X 88.110-26

MODELS 4

40, 45

## STARTER HOUSING

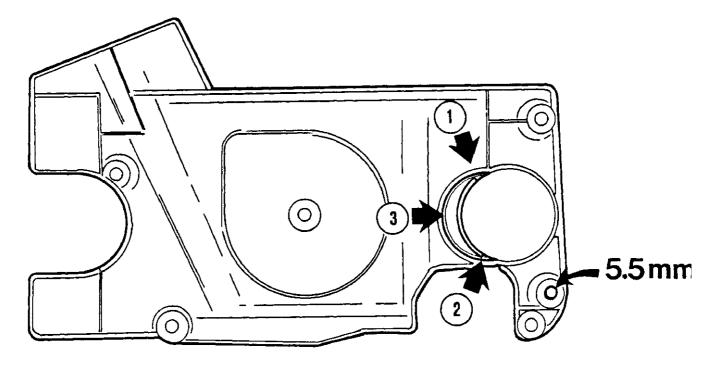
According to SB 88.129-26, crankcases are changed from serial number 8310101 (40) and 8180710 (45).

The oil filler hole is moved forward and therefore a new starter housing is introduced, at the same time: Ref. No. 503 10 59-04 replaces Ref. No. 503 10 59-01.

The new starter housing does not fit on the old crankcase. It is, however, prepared for easy modification and removing of some material.

This material looks like a "halfmoon" in the illustration framed by the arrows 1, 2 and 3. First remove the attachment of the "halfmoon" in the housing at the arrow 1 resp. 2. Then the material is removed along the groove illustrated at the arrow 3. Use a knife or a screw driver for this operation. If there are some rough edges, smoothen these off.

A hole must be drilled in order to screw the starter housing in the old crankcase. Use a drill  $\varnothing$  5,5 mm. (7/32").
